SEWAGE DISPOSAL SYSTEM

MARYLAND STATE DEPARTMENT OF HEALTH DISTRICT 4th

SUBDIVISION McKendree View ROAD 2289 McKendree View LOT 4

PROPERTY OWNER G. Edgar Pugh, Jr.

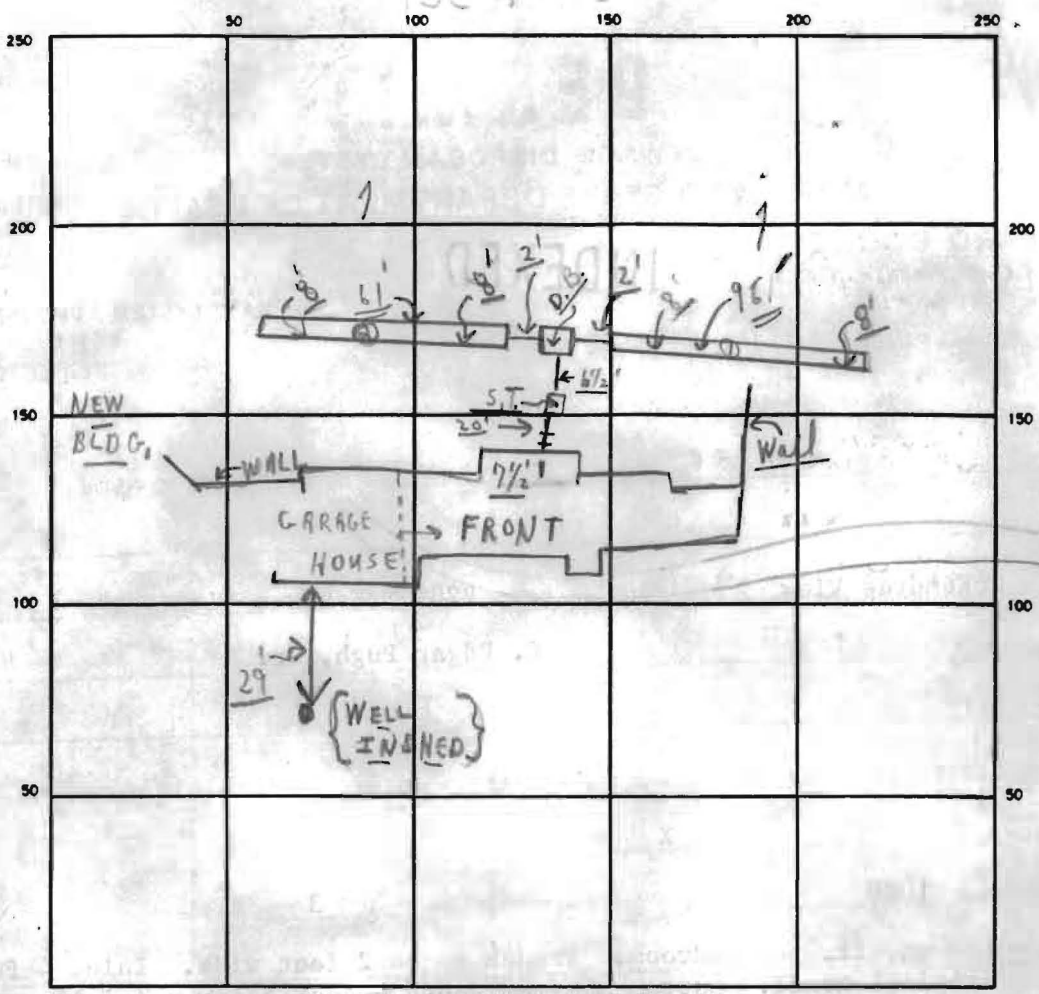
Notes 7/8
 Trench 30' L
 ① 7/8' complete
 Total Trench 90'
 ② 21' gravel pipe

SEPTIC TANK LEVEL OK (2000) CLEANOUTS OK
 DISTRIBUTION BOX LEVEL OK (Yes traffic)
 DRAIN FIELD/TILE FIELD. DEPTH 8 FT. TRENCH WIDTH 2 FT. INLET DEPTH 4 FT.
 EFFECTIVE GRAVEL DEPTH 4+ FT. TOTAL LENGTH 96' 67' } 157 FT. $\frac{130}{90} = 220'$
 NUMBER OF TRENCHES 2 ONE SIDEWALL/BOTTOM AREA 880+ SQ FT.
 DRYWELL INSIDE DIAMETER — FT. EFFECTIVE DEPTH BELOW INLET — FT.
 ABSORBENT AREA 880+ SQ FT.

REMARKS ① PARTIAL 9/7/89 P.M. OK FOR STONE, ONLY, IN TRENCHES; 9/8/89 ① TRENCHES DUG LONGER & STONED, PARTIALLY OK TO COVERT 1' OF DIST. BOX FROM HOUSE; ② FINAL, OK TO FINISH TRENCHES WITH STONE; PIPE & PAPER TO 4' IF GRADE AND COVER. C.B.D.
